RE: Tamrock Gravel LLC. - Shot Rock Pit
Permit # M-2012-023 - Adequacy Review

On behalf of our client Tamrock Gravel LLC., I will respond to your July 27, 2012 adequacy review letter, as needed, in the order and number format presented in that document.

TAMROCK GRAVEL COMPANY
RECLAMATION PLAN MAP
EXHIBIT F - OPTION A

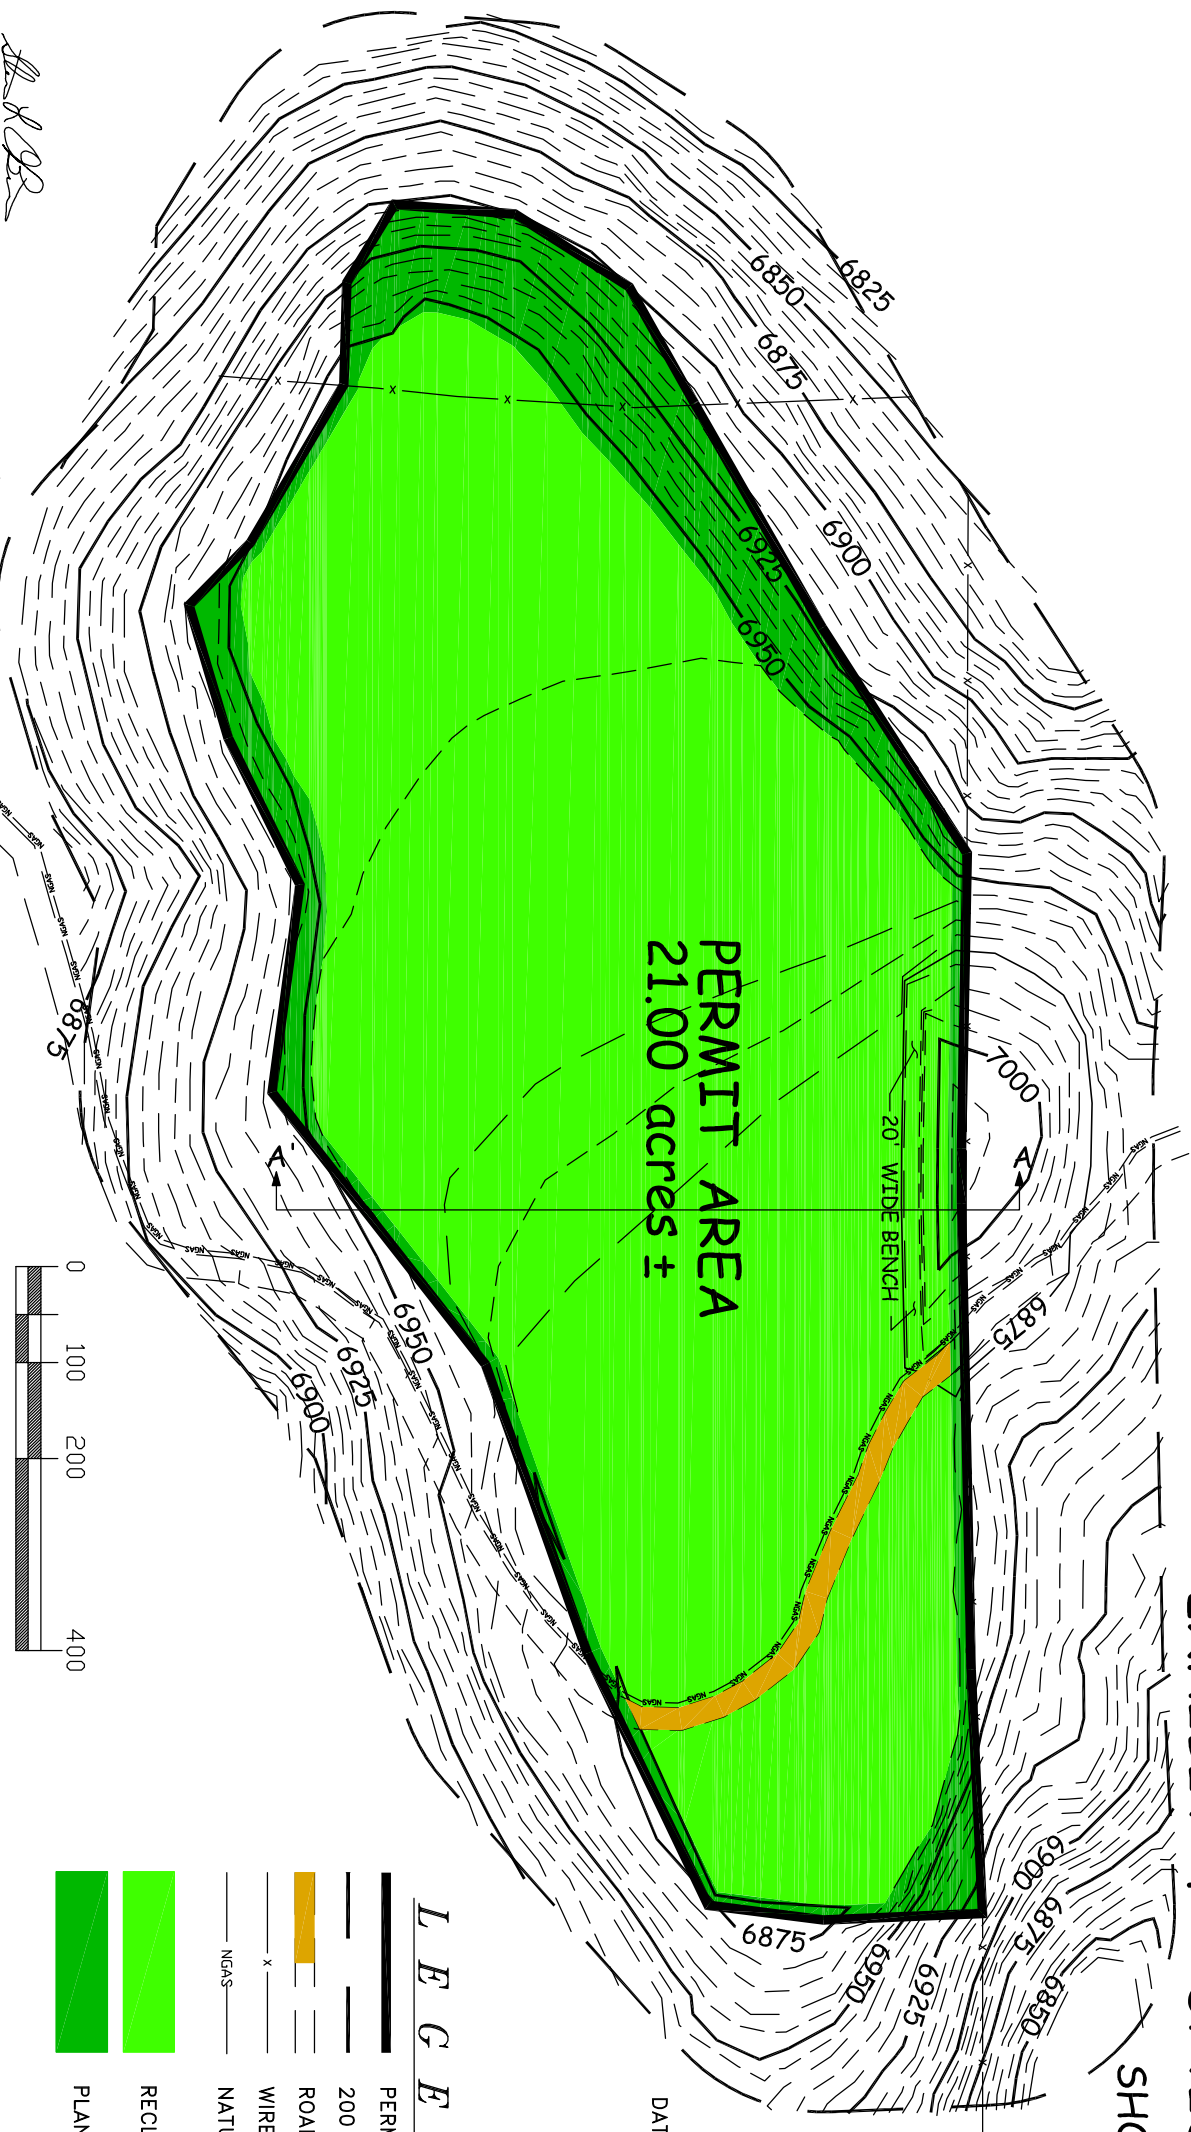
- The reclamation plan needs to include grading or backfilling all remaining slopes to a 3:1 or flatter grade. If benching will be used for final slopes, then an overall grade of 3:1 should be achieved. Both of the options discussed for reclamation include leaving a remaining rock face of 25 to 70 feet high. To be in compliance with Rule 3.5.1, the final grade should be compatible with the surrounding topography and shall be done in a manner to control erosion and consistent with the post-mining land use. In the Division's experience, a final slope grade of 3:1 or flatter is required.

- Please revise the reclamation plan maps and cross sections to reflect the comments in 6.4.5 above pertaining to final slope grades. All final slope grades for mined areas should be 3:1 or flatter.

I have revised the cross section on Figure F-1 to show two probable scenarios. In A-A' the reclaimed face height is 30 feet high, the first bench will be 15 feet below the top and will be 30 feet wide, the second bench height will be 15 feet high. In B-B' the reclaimed face height is 20 feet high, the first bench will be 10 feet below the top and will be 20 feet wide, the second bench height will be 10 feet high. The Reclamation Plan Maps have been revised showing a benched rock face.

TAMROCK GRAVEL COMPANY MINING PLAN MAP - EXHIBIT C-1 SHOT ROCK PIT

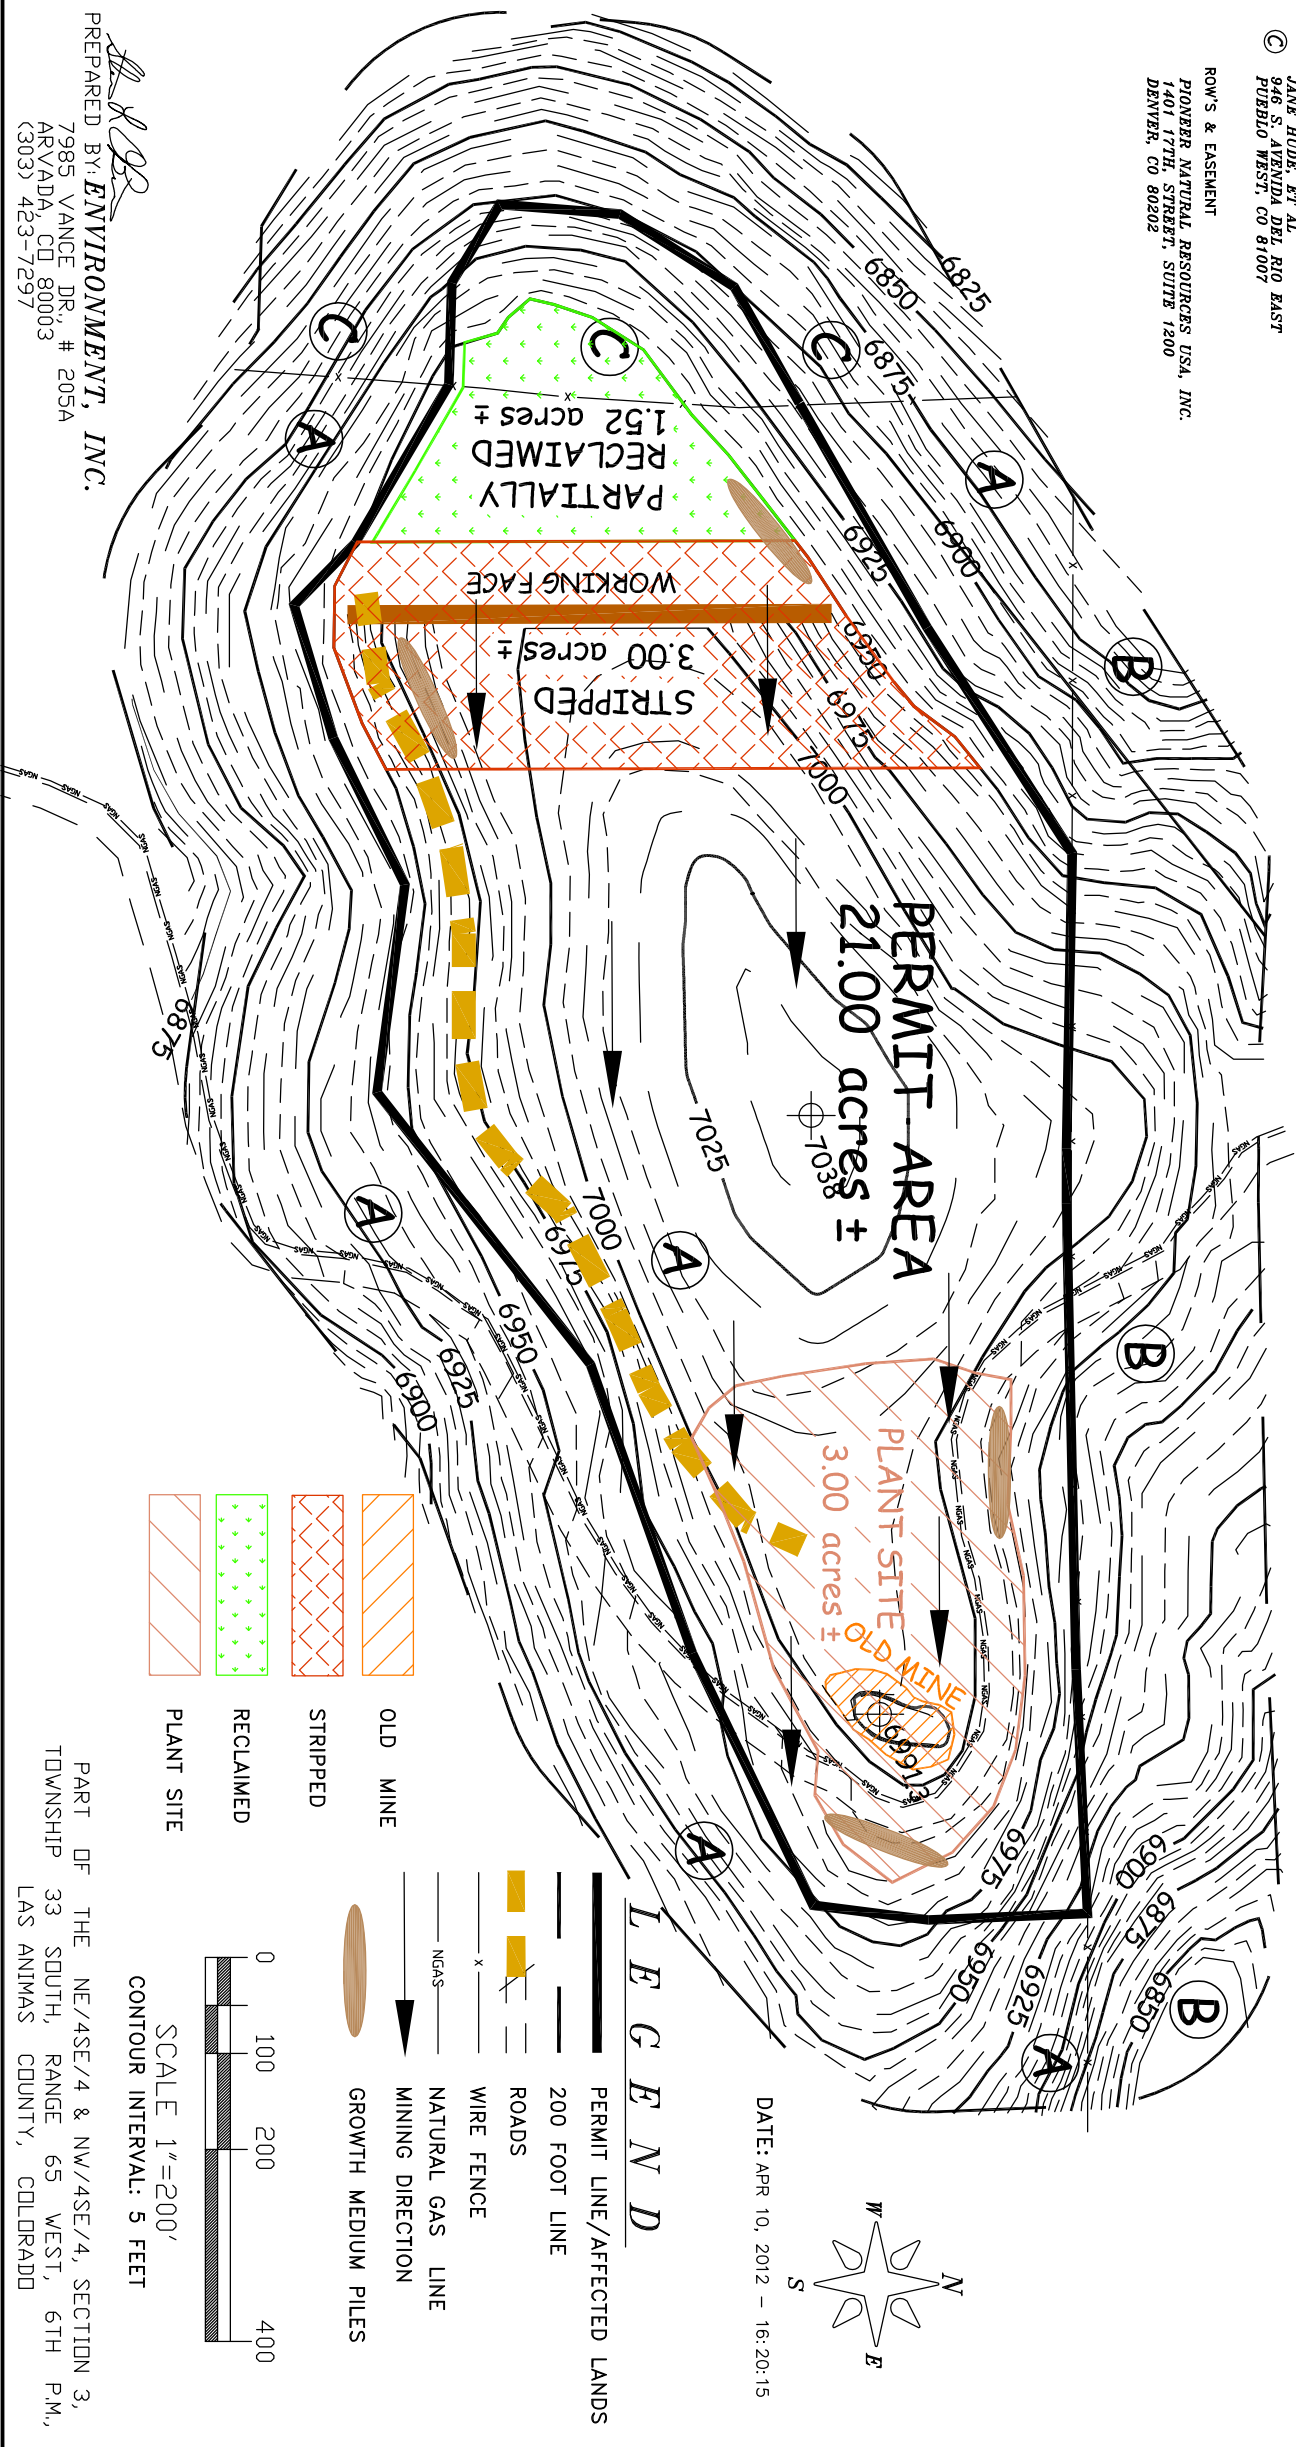
- Exhibit C-1: Please show the location of the topsoil stockpiles.

I forgot to add them to the map. Attached is a corrected copy showing the approximately location of growth medium piles around the active mine area. I also added a label for the raw material haul route (dashed brown line).
